UNITED STATES PATENT AND TRADEMARK OFFICE

09/788,420

Office Action Summary	Application No. 09/788,420	Applicant(s) KWON ET AL.	
	Examiner TIMOTHY RUDE	Art Unit 2871

DETAILED ACTION

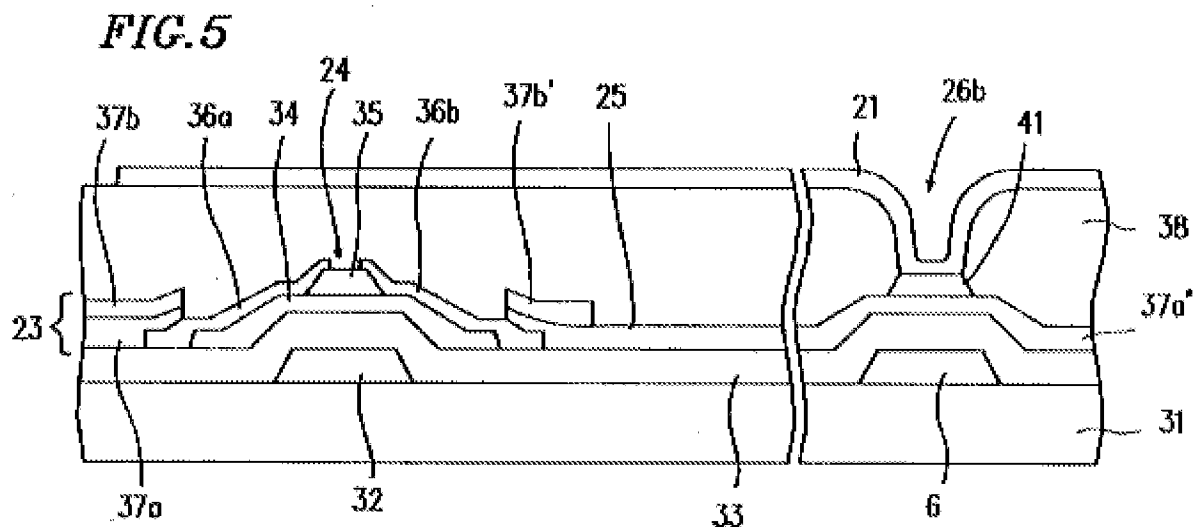
As to claims 1, 8-9, and 28, AAPA discloses a liquid crystal display (LCD) device (Fig. 1E) having a substrate (10), first conductive layers (12A and 14A) on the substrate, a first insulating layer (16) having a contact hole (above 14A) exposing a portion of the first conductive layers (allowing electrical connection to 14A via contact hole above 14A); a semiconductor layer (18) on the first insulating layer [Applicant's first conductive layers – correction is recommended, although not required]; second conductive layers (20) on the semiconductor layer, third conductive layers, (22A and 24A), on the second conductive layers, a second insulating layer (26) on the third conductive layers, the second insulating layer having a first contact hole exposing a portion of the third conductive layers (contact hole for pixel electrode) and a second contact hole (hole for 30) exposing the portion of the first conductive layers exposed by the first insulating layer, a fourth conductive layer (28) on the second insulating layer and electrically contacting a portion of the third conductive layers, and a fifth conductive layer (30) on the second insulating layer and electrically contacting the first conductive layers through the second contact hole; and sixth conductive layers, (24B and 14B), between and in

contact with both the exposed portion of the third conductive layers (24A) and the fourth conductive layer, (28), and between and in contact with both the first conductive layers, (14A), and the fifth conductive layer, (30), wherein the sixth conductive layers are formed in the first contact hole and in the contact hole of the first insulating layer [sixth layers 24B and 14B exist at the bottoms of (Applicant's formed in) the contact holes]. Please note, this is a device claim whereby "formed in" is considered to limit where structure is as opposed to how it got there. Also, something that is at the bottom of a hole is reasonably considered to be in the hole.

APA does not explicitly disclose an embodiment wherein the sixth conductive layers are exclusively and entirely contained at the bottoms of the first contact hole and the bottom of the contact hole of the first insulating layer.

(1) It is respectfully pointed out that APA discloses the device comprising sixth conductive layers, (24B and 14B), between and in contact with both the exposed portion of the third conductive layers (24A) and the fourth conductive layer, (28), and between and in contact with both the first conductive layers, (14A), and the fifth conductive layer, (30), wherein the sixth conductive layers are formed in the first contact hole and in the contact hole of the first insulating layer [sixth layers 24B and 14B exist at the bottoms of (Applicant's formed in) the contact holes]. Please note, this is a device claim whereby "formed in" is considered to limit where structure is as opposed to how it got there. Also, something that is at the bottom of a hole is reasonably considered to be in the hole.
